Subject: Braidwood Station Unit 1
NRC Docket Number: 50-456

Response to Request for Additional Information Pertaining to Operating Interval
Between Eddy Current Inspections for Circumferential Indications in the
Braidwood Unit 1 Steam Generators

ATTACHMENT A
REQUEST FOR ADDITIONAL INFORMATION
RELATED TO THE BRAIDWOOD, UNIT 1 CYCLE LENGTH ASSESSMENT
BASED ON STEAM GENERATOR (SG) TUBE
CIRCUMFERENTIAL INDICATION GROWTH RATES
DOCKET NUMBER 50-456

Figure 5.5

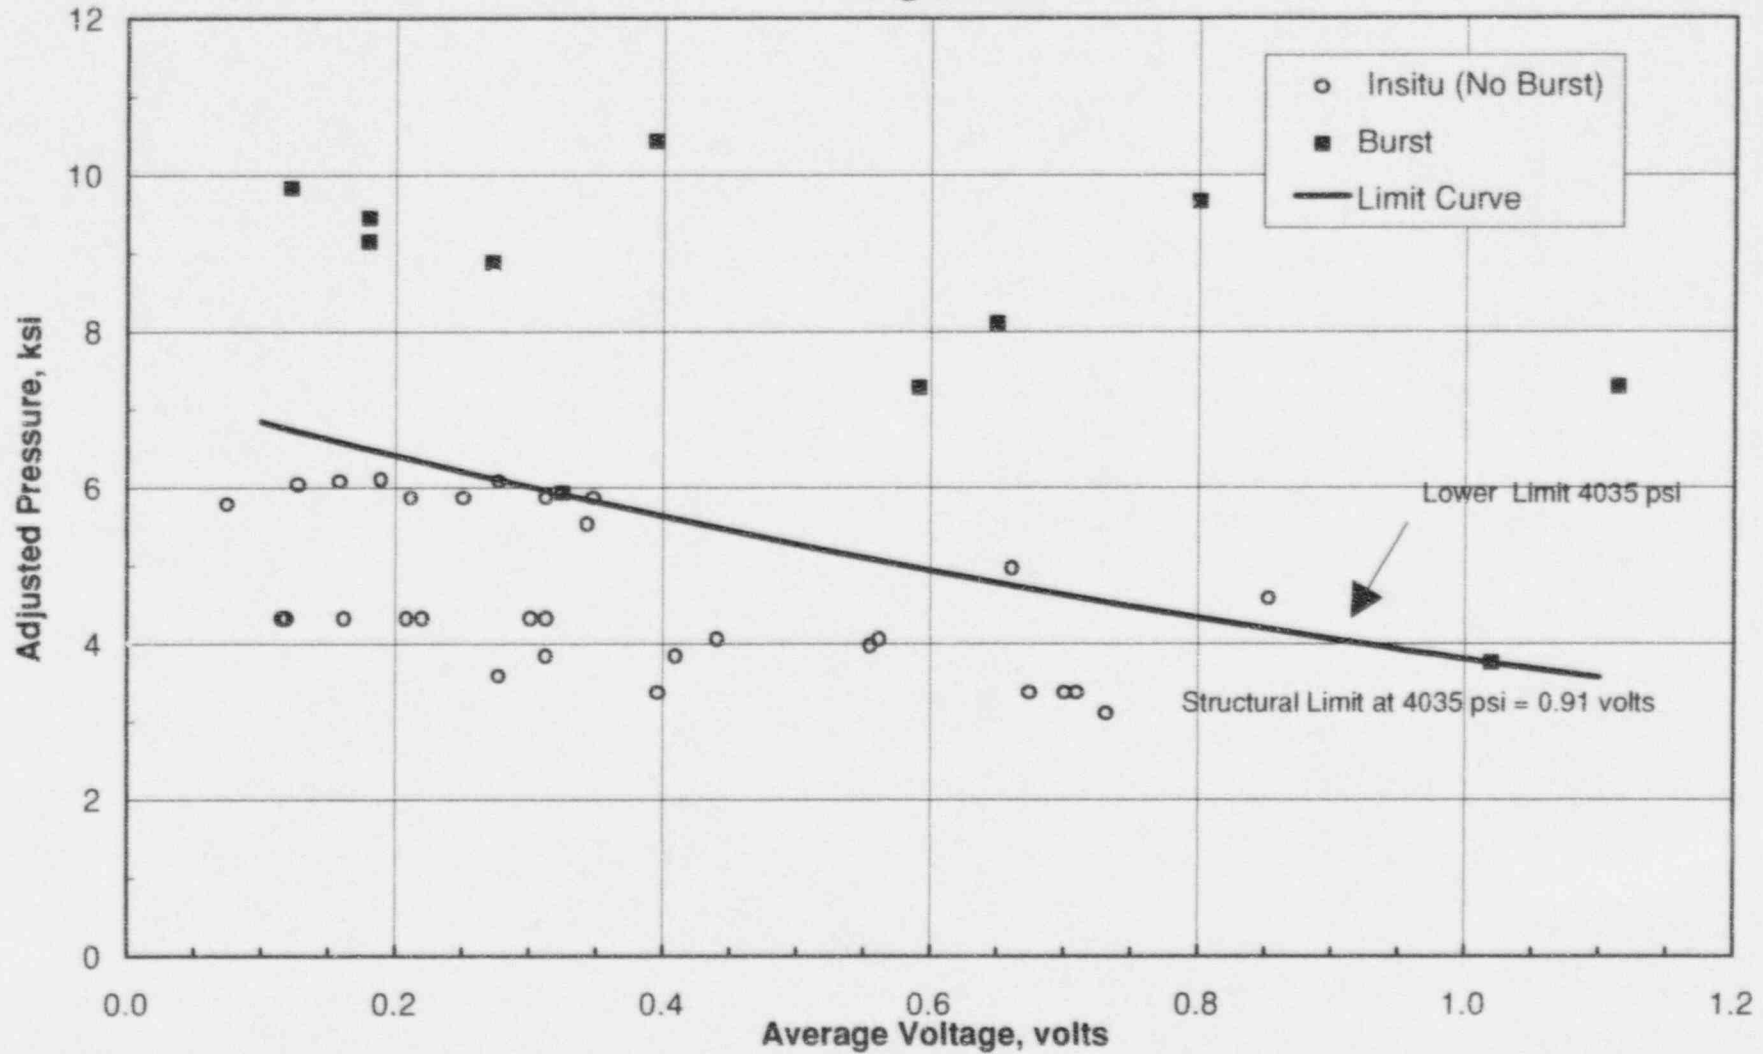
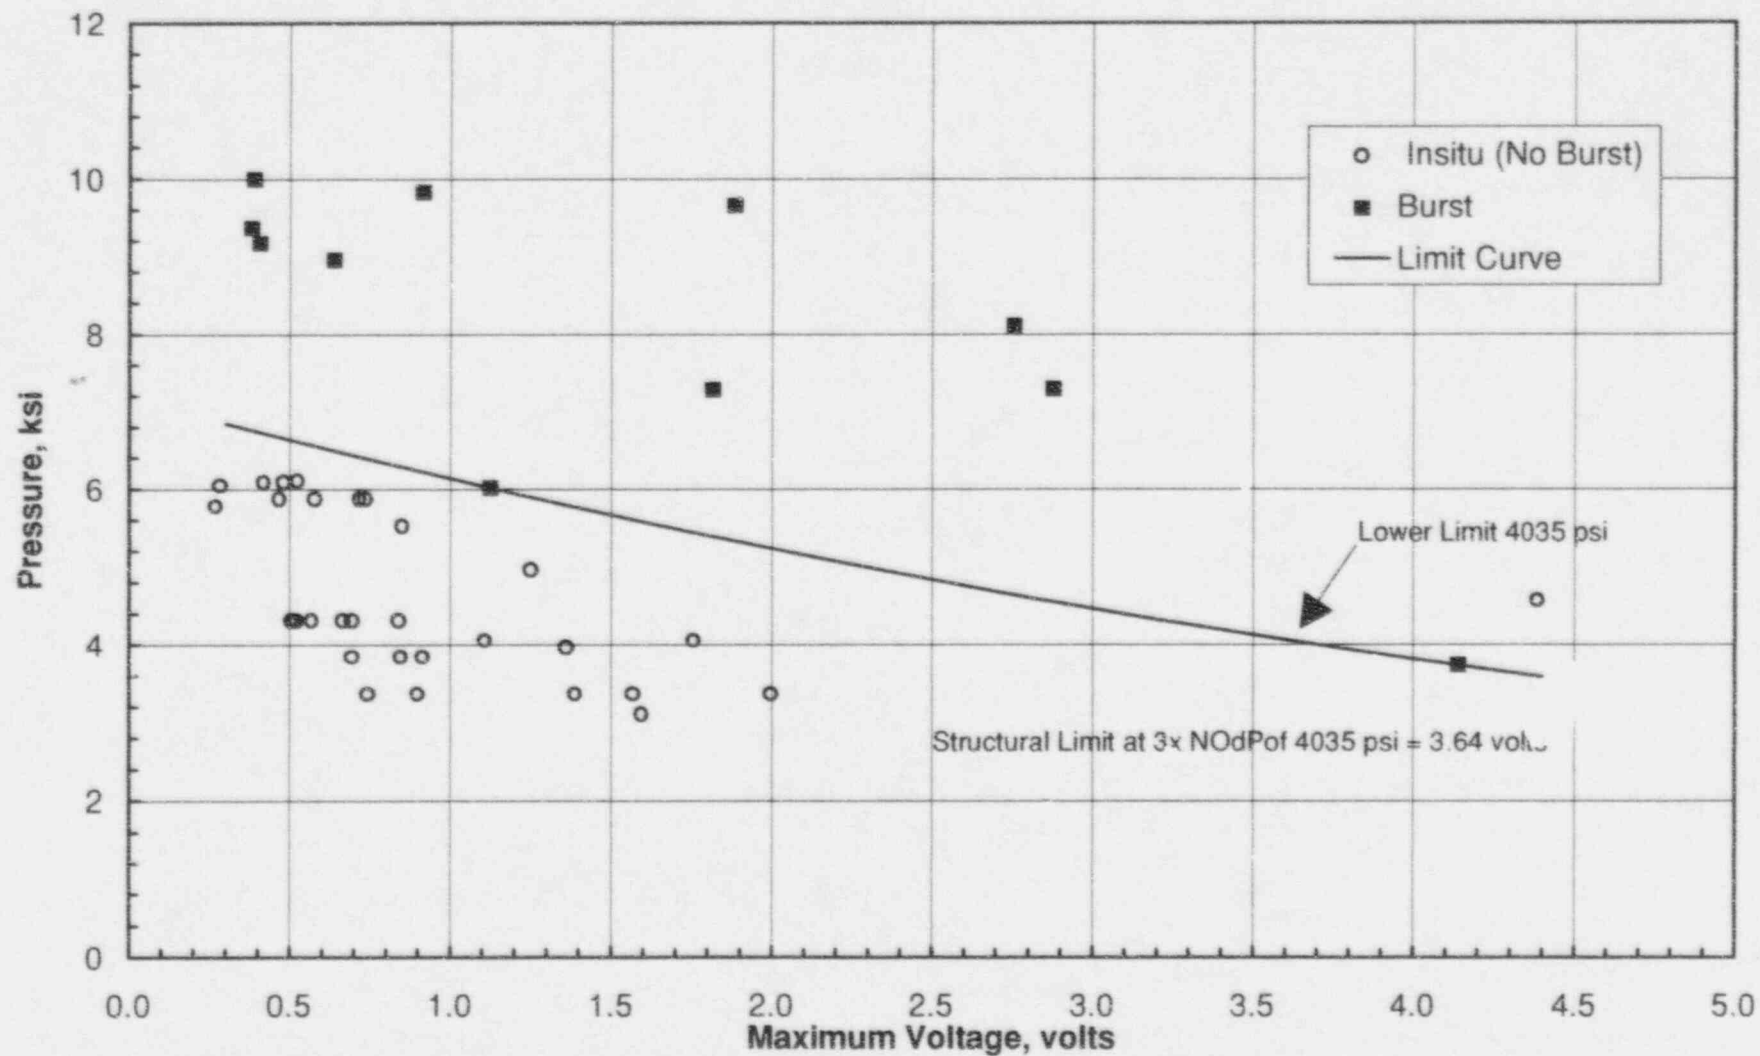
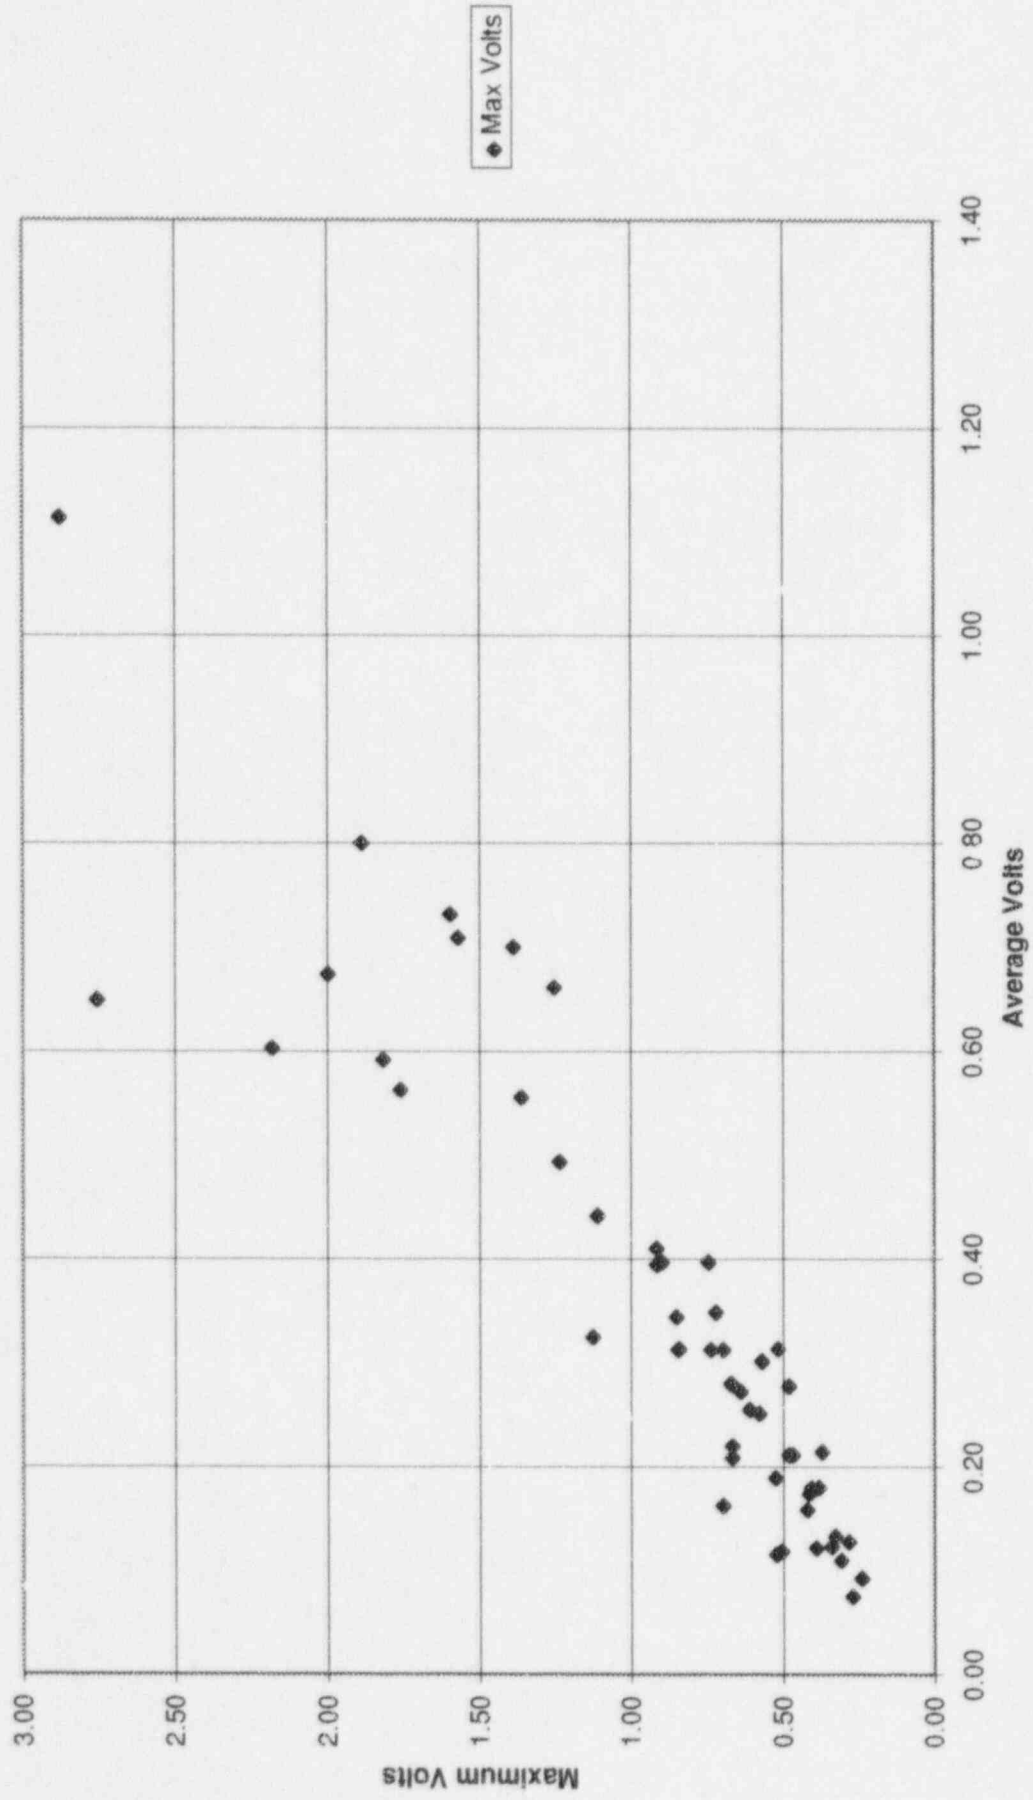
1. August 2, 1996, Submittal, Figure 5.5, 5.6 and 6.1 do not include one insitu pressure test point. Data for this test was acquired subsequent to the submittal and therefore it was not included in the figures. The point is located at 0.67 max Volts and 0.28 avg. Volts corresponding to a corrected test pressure of 3.577 ksi.

This additional point has been included in all analyses. The additional data point does not change the results or conclusions of the report. Additionally, the axes on Figure 6.1 were incorrectly labeled in the August 2, 1996 submittal. The updated Figures 5.5, 5.6 and 6.1 are attached.

Figure 7.1

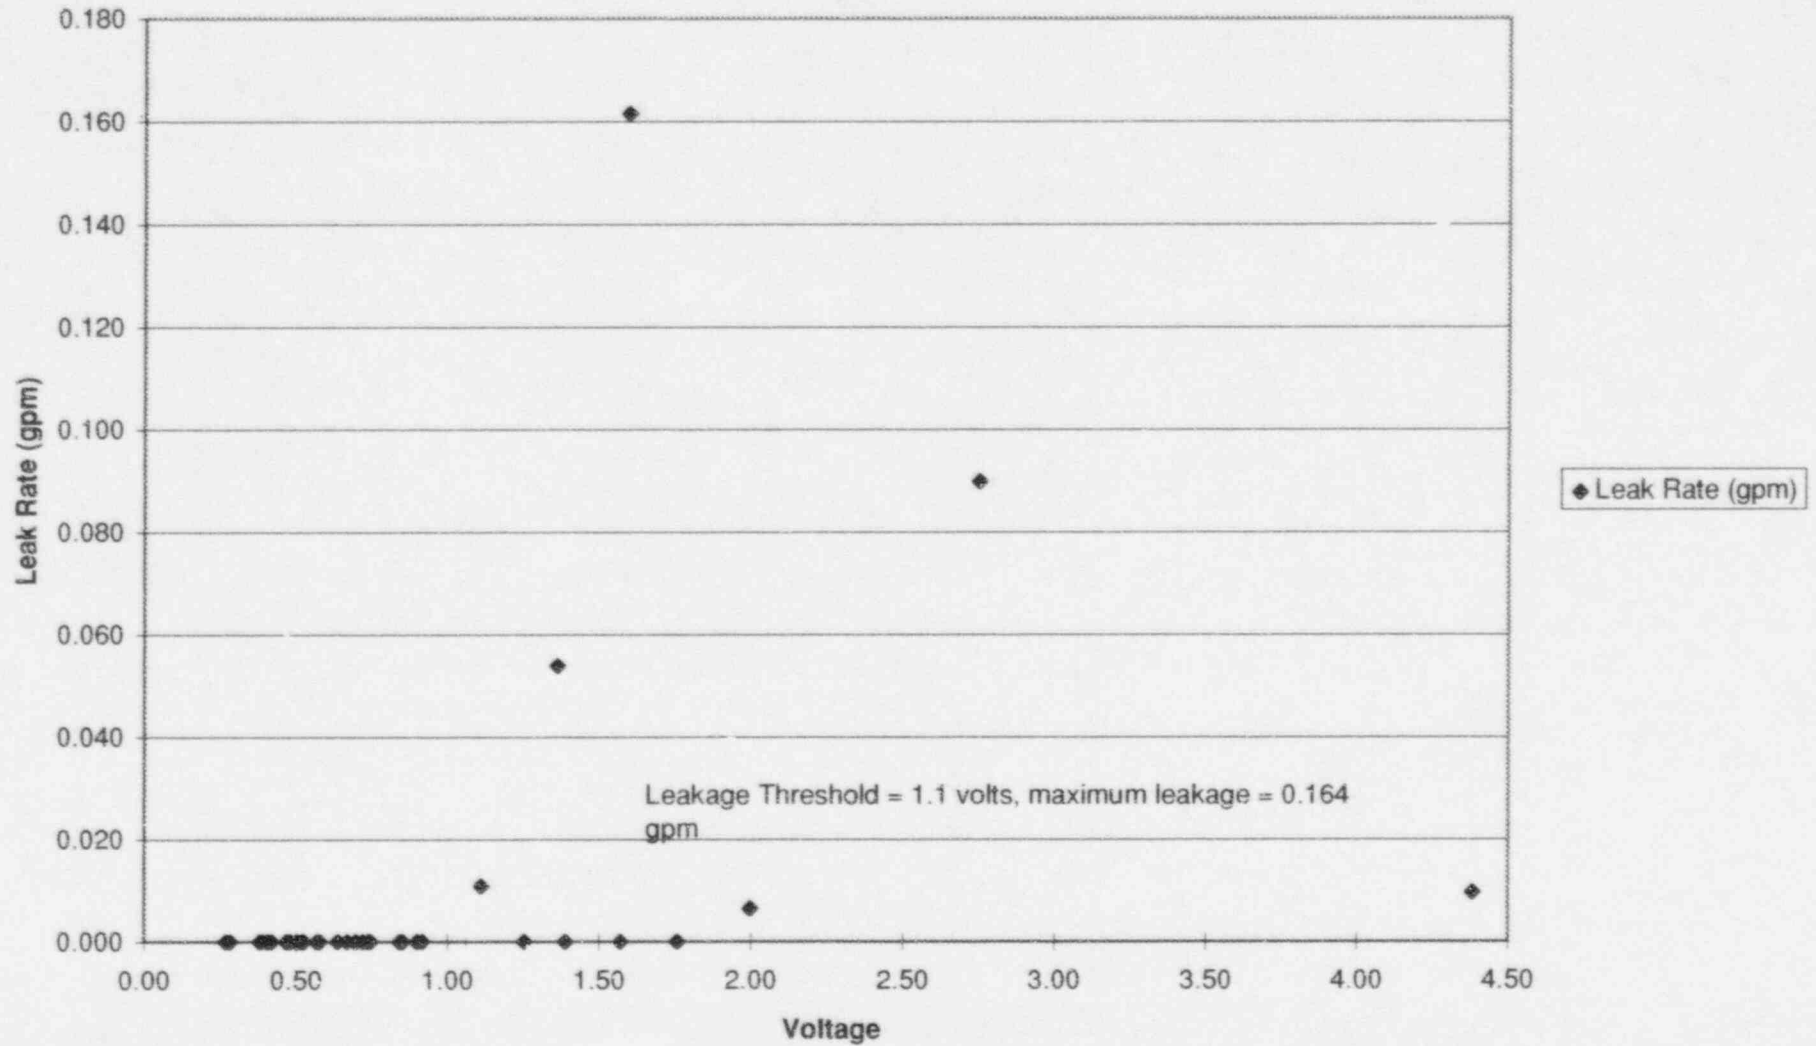
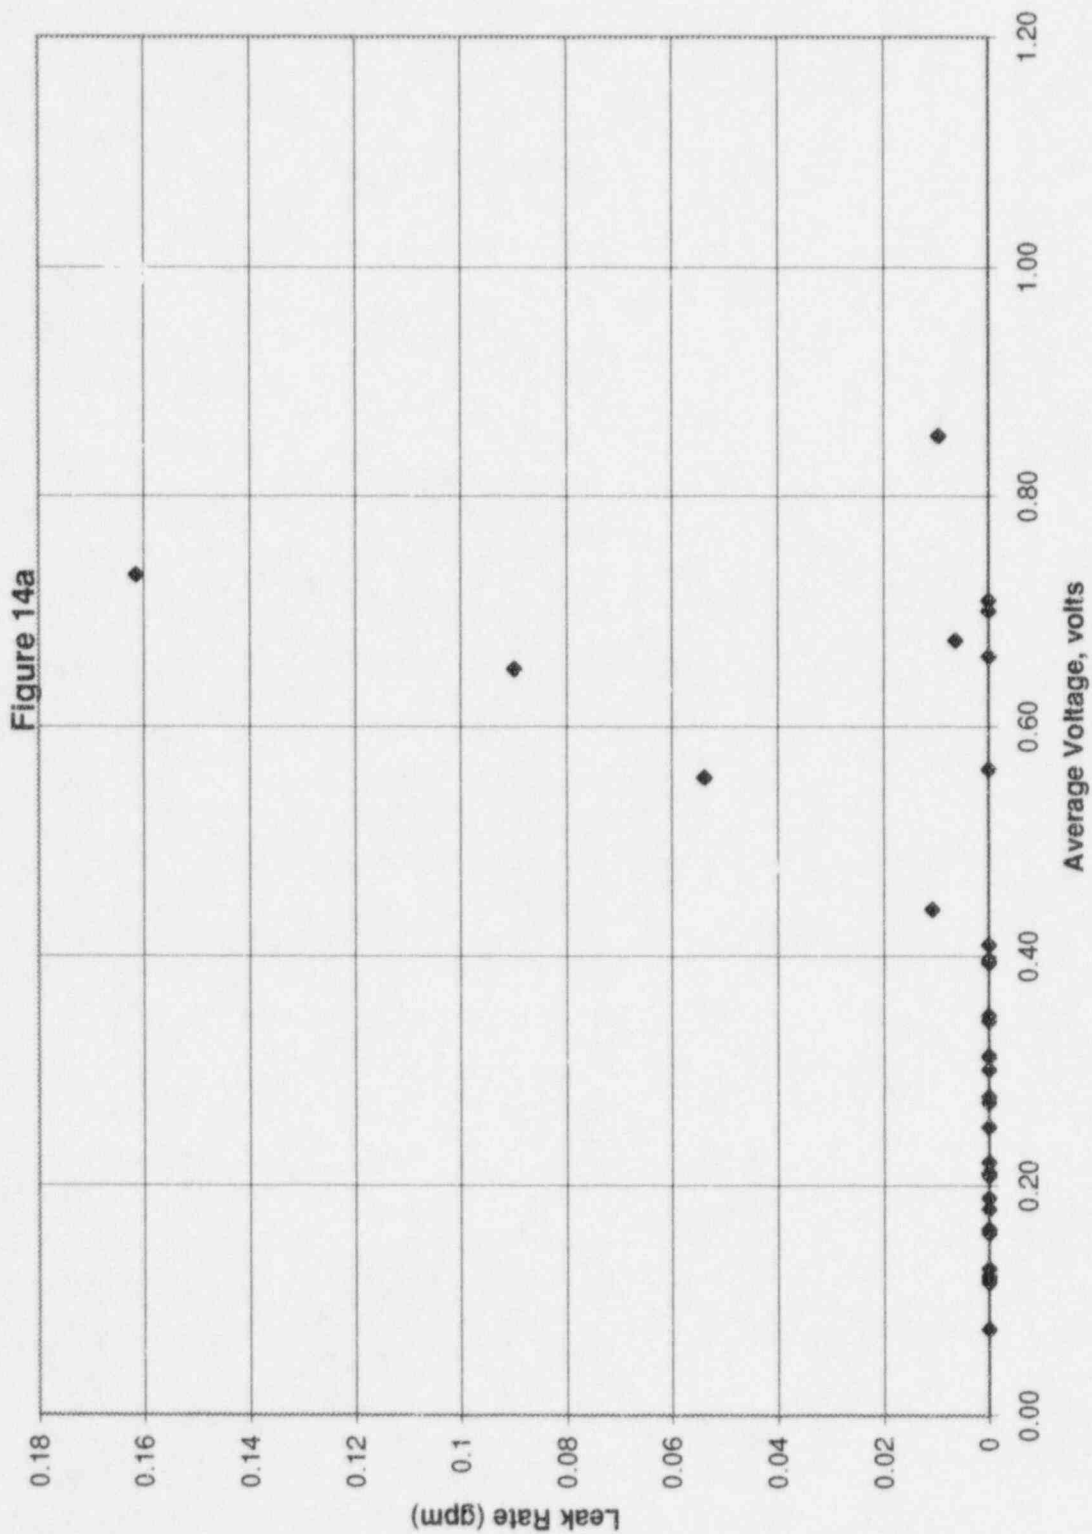
2. The leak rate of one of the data points in the August 2, 1996, submittal Figure 7.1 and Figure 14a in the September 10, 1996, submittal had an incorrect leak rate. The leak rate was previously presented on these figures as 0.00352 gpm. This leak rate was incorrectly calculated for the maximum pressure instead of the leak test pressure. The correct leak rate is 0.0064 gpm. Because a bounding leak rate is assumed for the EOC distribution this change has no effects on the report conclusions or the EOC predicted leak rate.
